UNITED STATES PATENT AND TRADEMARK OFFICE

APPLICATION NO.	FILING DATE	FIRST NAMED INVENTOR	ATTORNEY DOCKET NO.	CONFIRMATION NO.
10/598,259	08/23/2006	Horst-Hartwig Schwieker	DE 040067	2040

Office Action Summary

DETAILED ACTION

Figs. 1 & 2 – X-ray apparatus – U.S. Patent 4,435,830 to Suzuki et al.

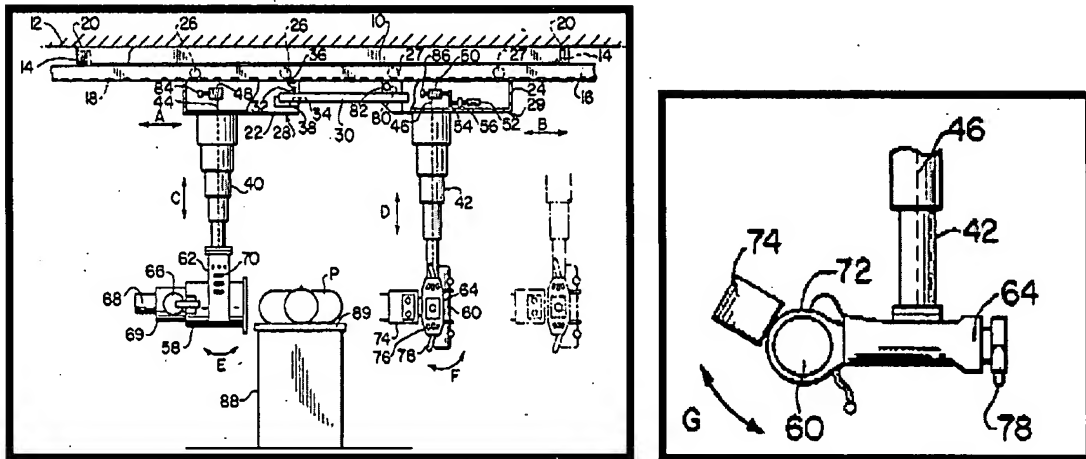
11. As per claims 1, 8 and 9, Suzuki et al. disclose a ceiling mount comprising: a first guide arrangement (14) affixed to a ceiling (12) in a room; a carrier system (28, 29) having a length adjustable arm (40, 42) the carrier (28, 29) being mounted to the first guide arrangement (14), so that it is movable in a first direction (A, B); a traverse arm (62, 64) mounted to an end of arm (40, 42) and rotatable around a first axis (E, F, G); an equipment carrier (not numbered - see Fig. 2 above) which is mounted to an end of traverse arm (62, 64) and carries an X-ray detector (58) or X-ray source (60). Schmitt does not explicitly disclose that traverse arm (63) is rotatable about a first axis of rotation.

12. **As per claim 3**, Suzuki et al. disclose a ceiling mount comprising a second guide arrangement (16) mounted to the first guide arrangement so that it is slidable along a second direction (column 3, lines 17-20) and a carrier (28, 29) mounted to the second guide arrangement so that it is slidable in a second direction and carries arm (40, 42).
